**ADDENDUM
NO. 3**

September 11, 2024

**LOGANSFORT JR. HIGH SCHOOL RENOVATIONS
Logansport, IN 46947**

1 UNIT "A" FIRST FLOOR ELECTRICAL DEMOLITION PLAN
ED101 1/8" = 1'-0"

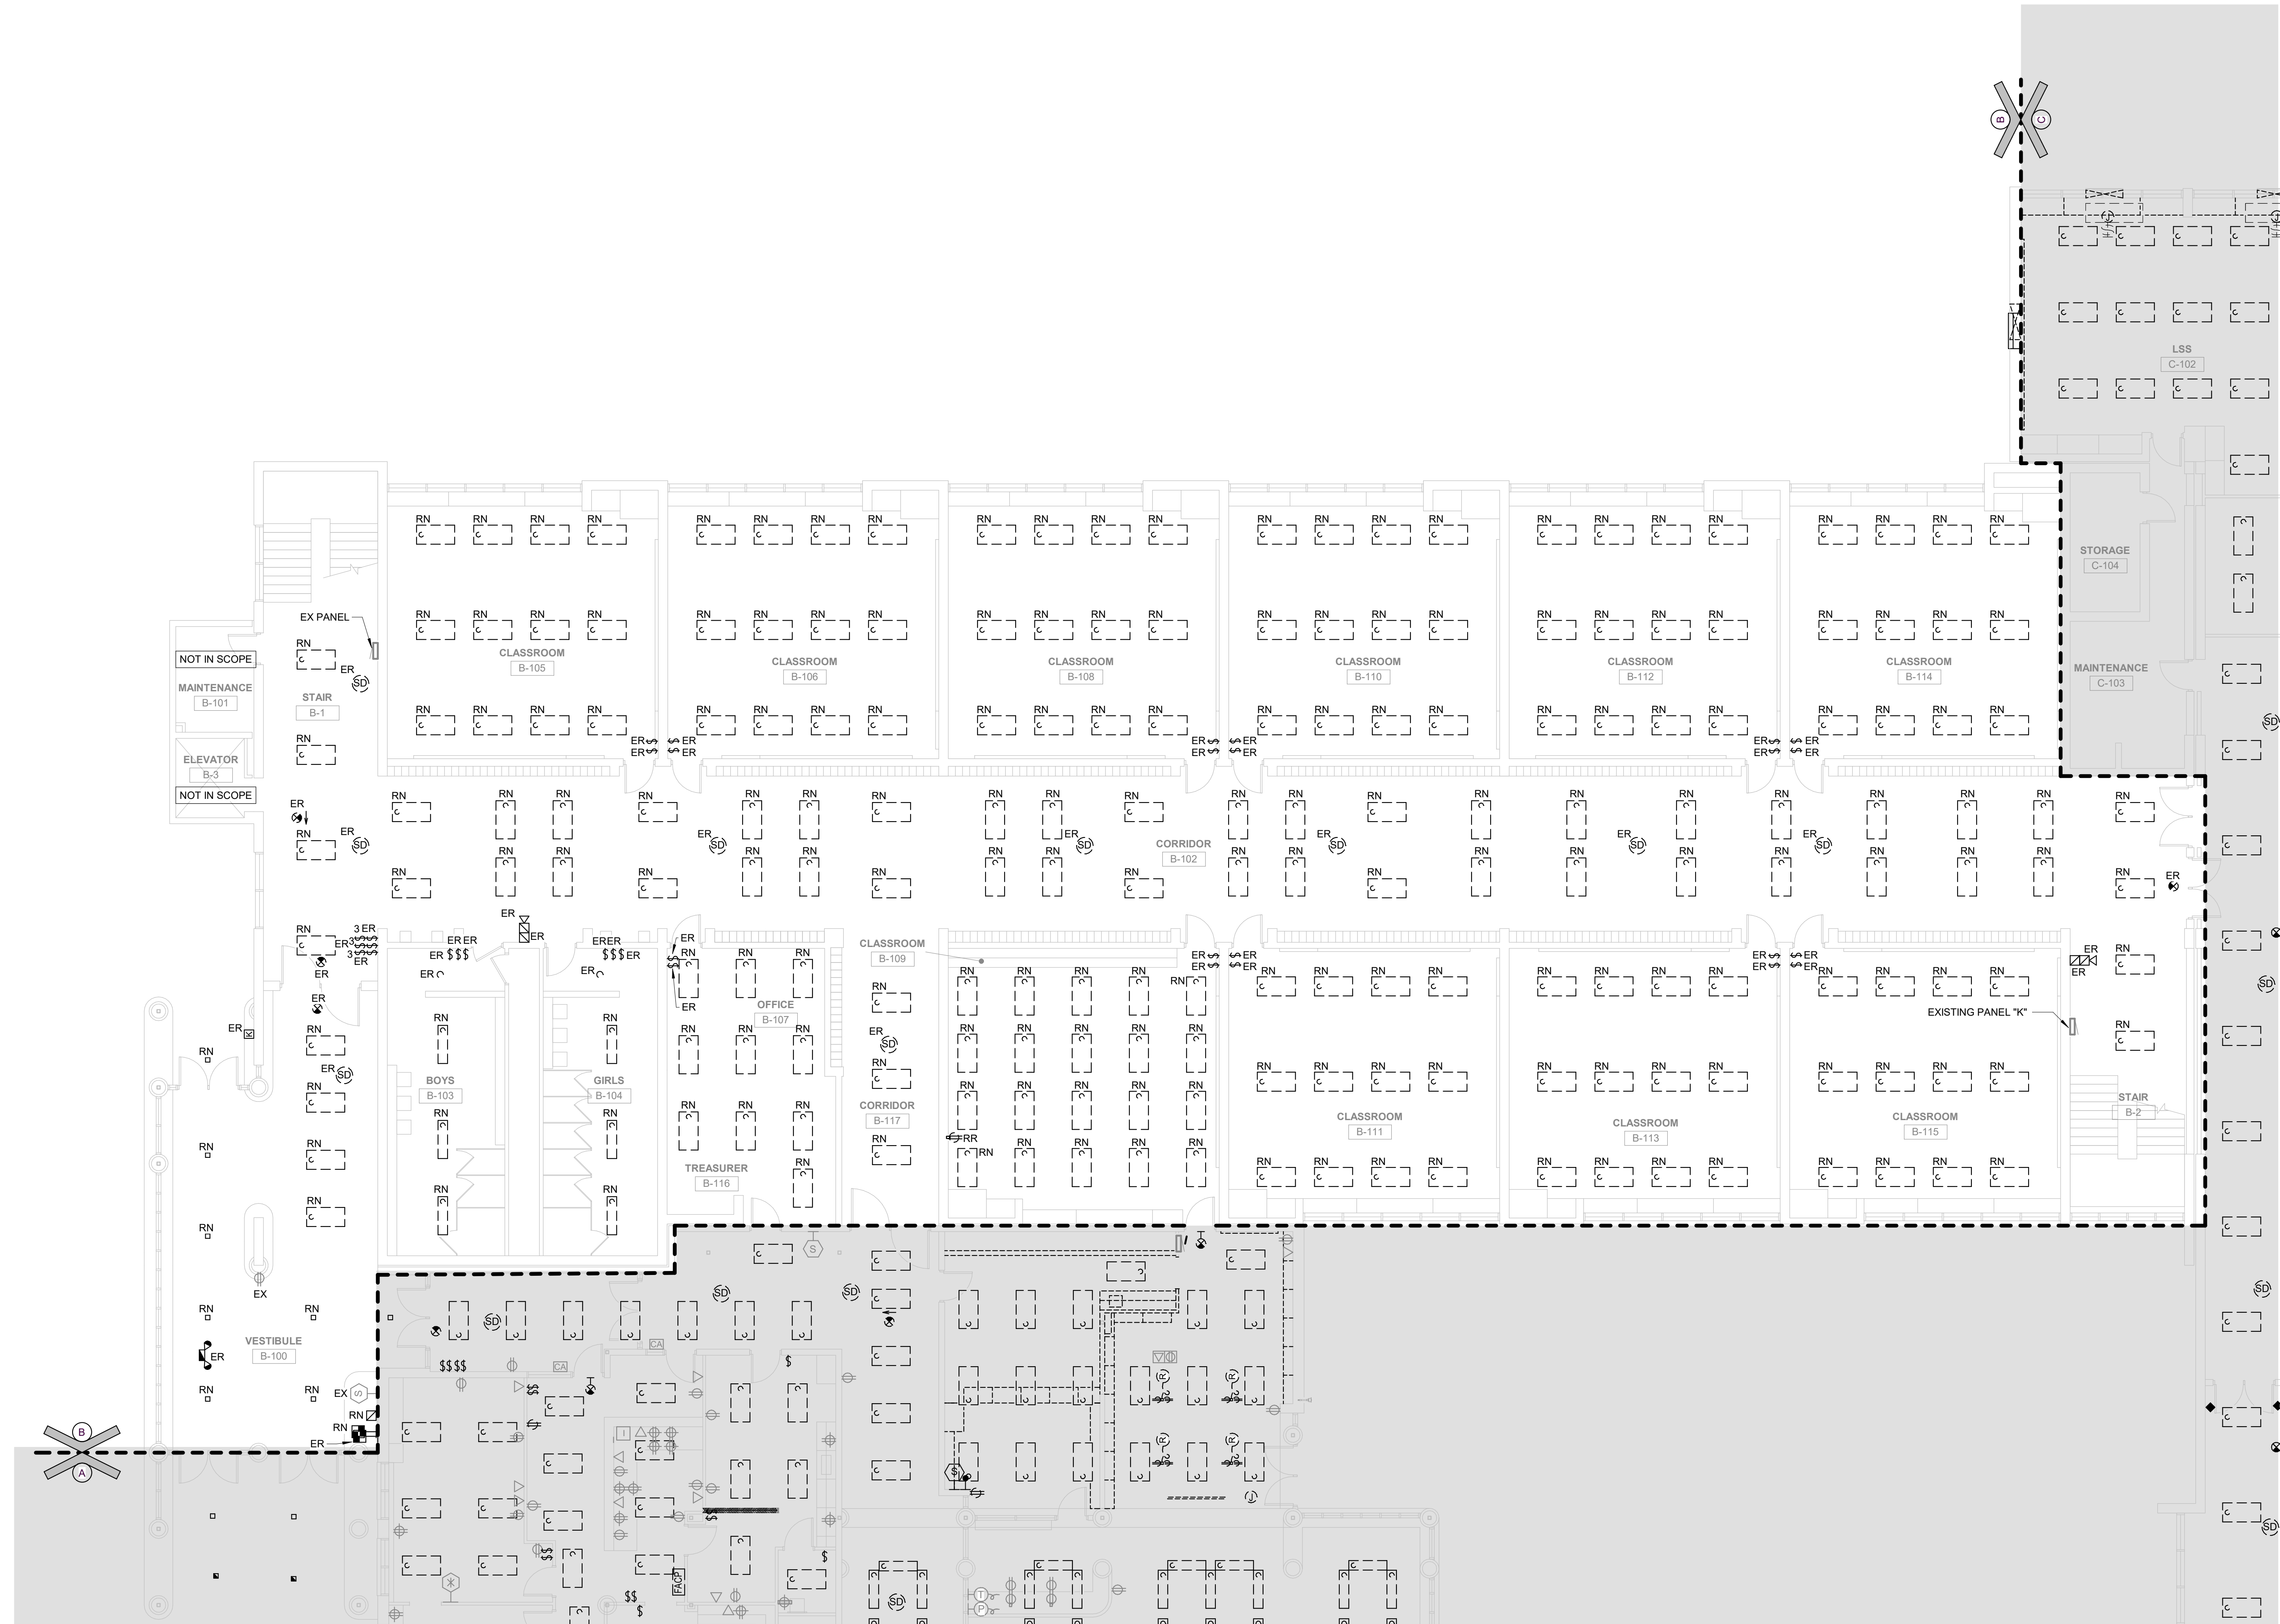
- A. Added low voltage demo scope.
- B. Revised demo scope.

© GIBRALTAR DESIGN SHEET
C ED103

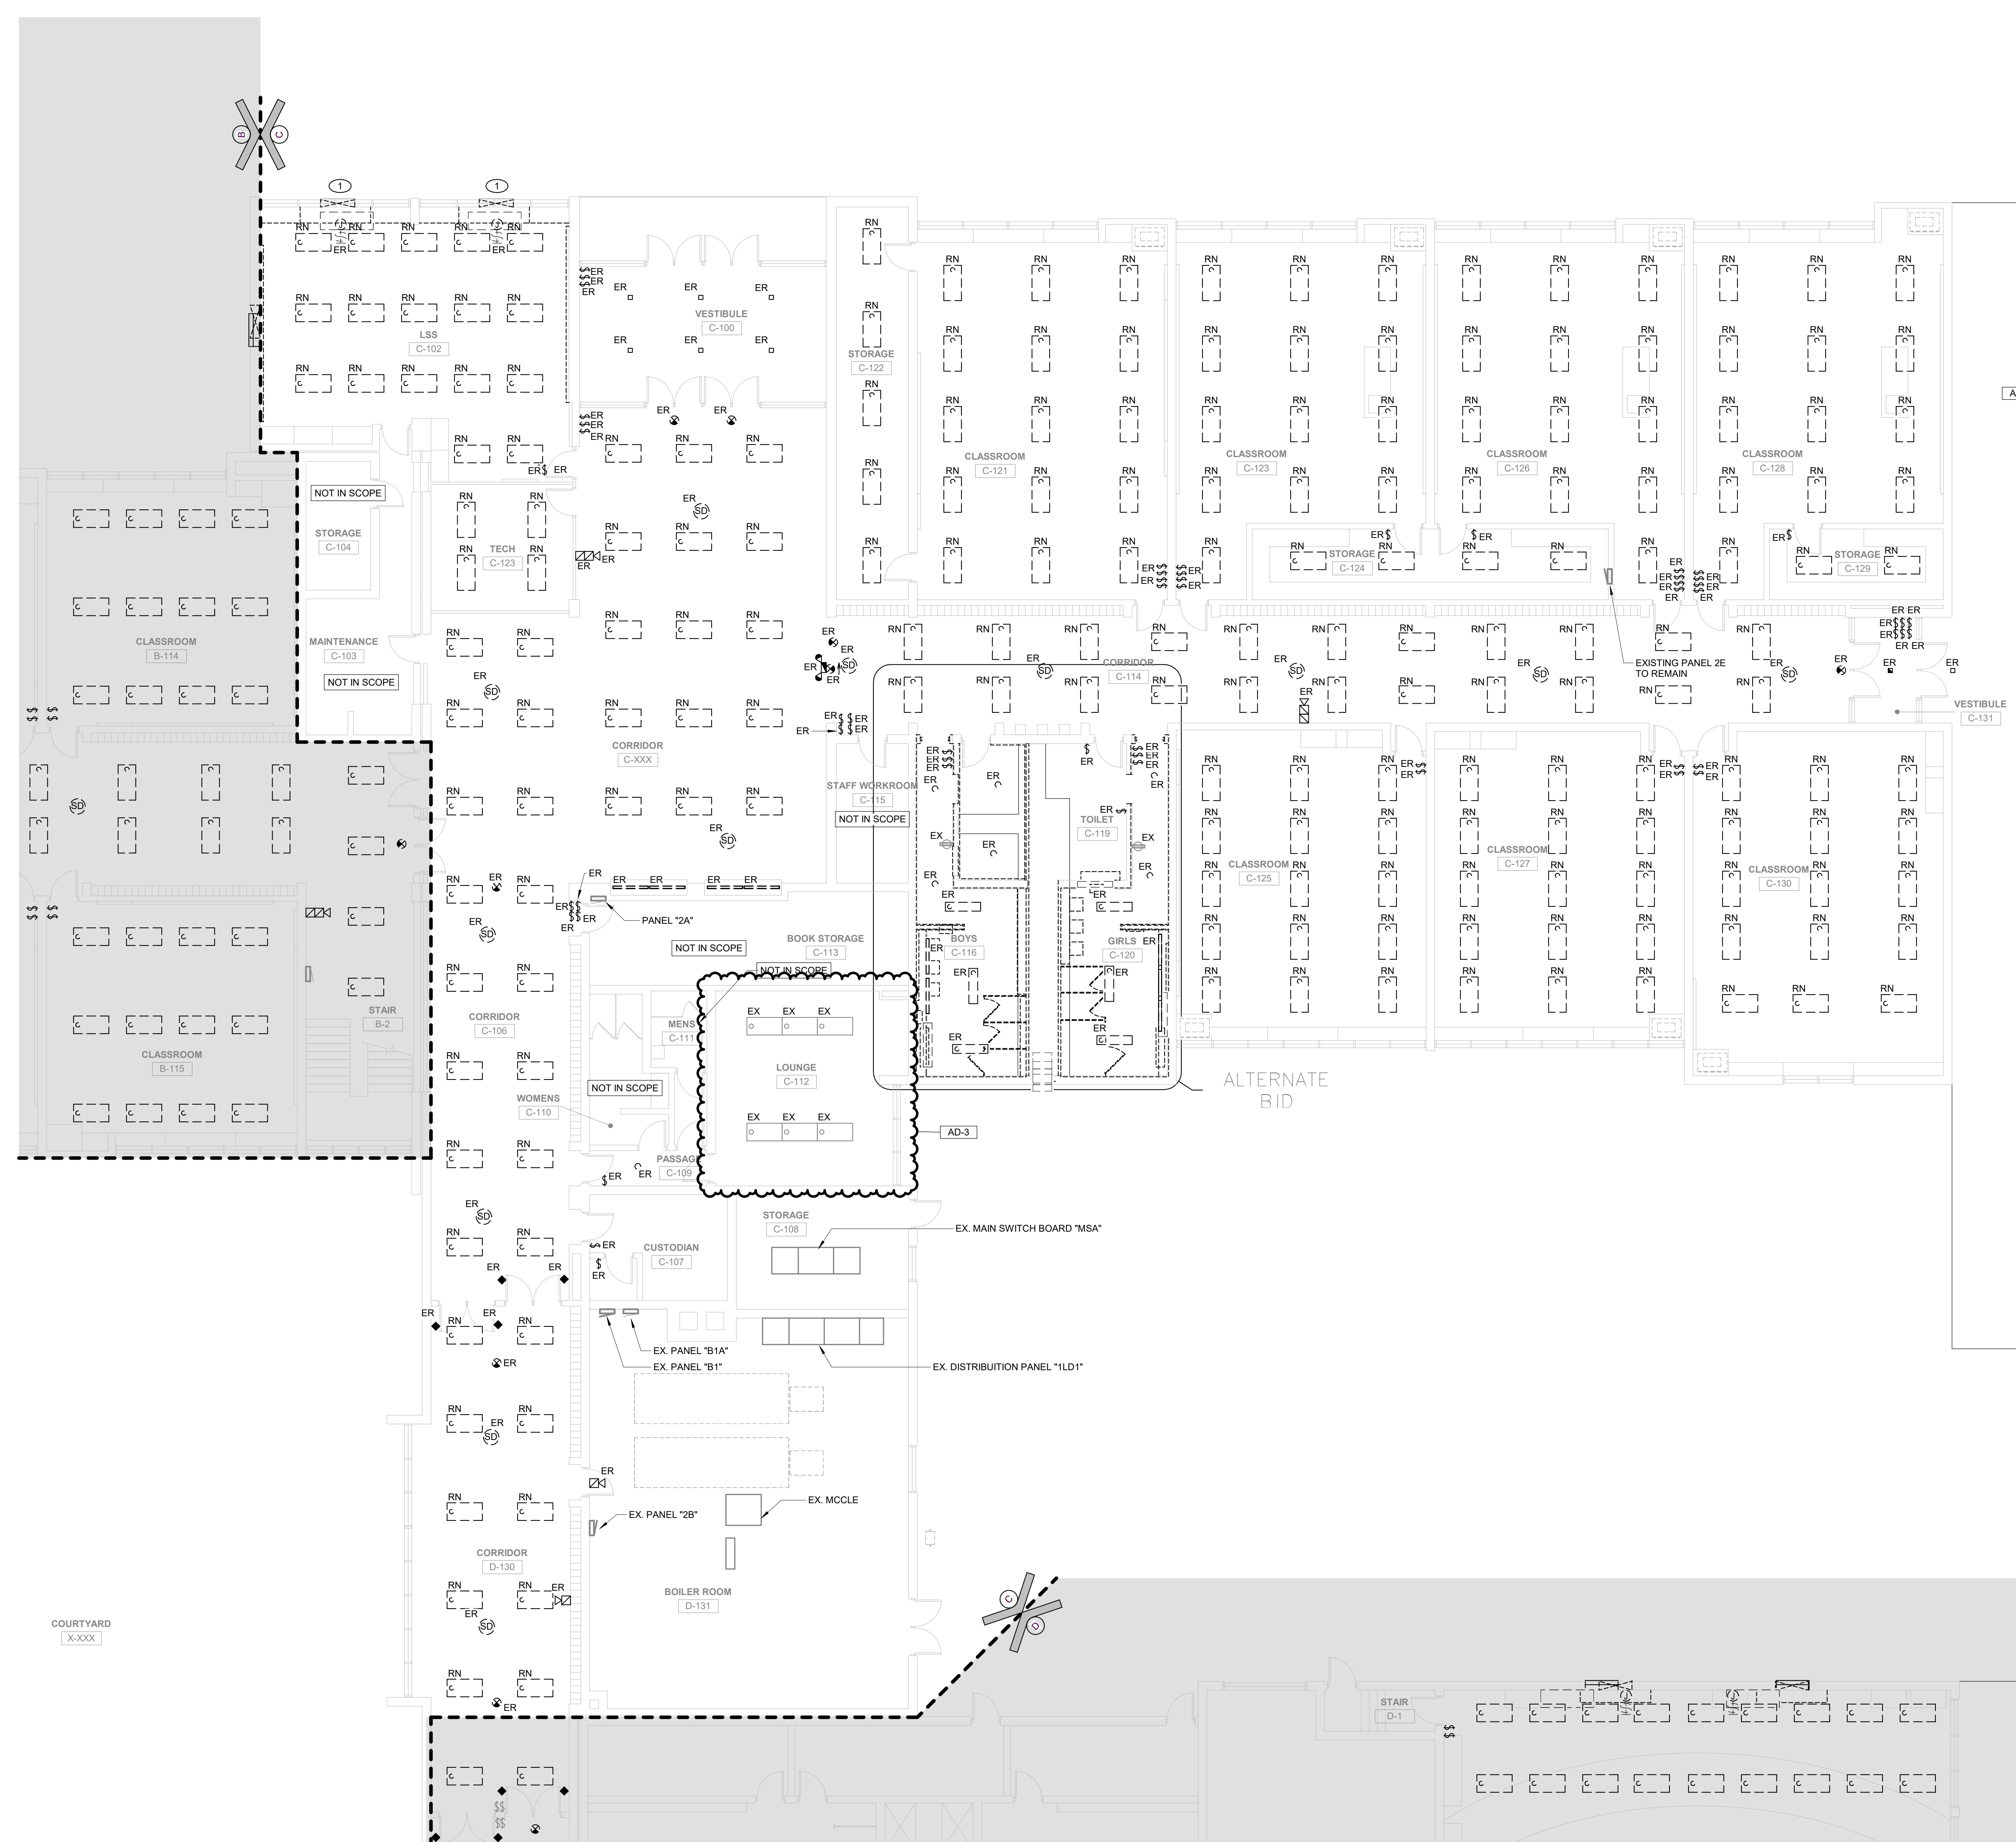
- A. Added low voltage demo scope.
- B. Removed demo scope at Lounge C-112
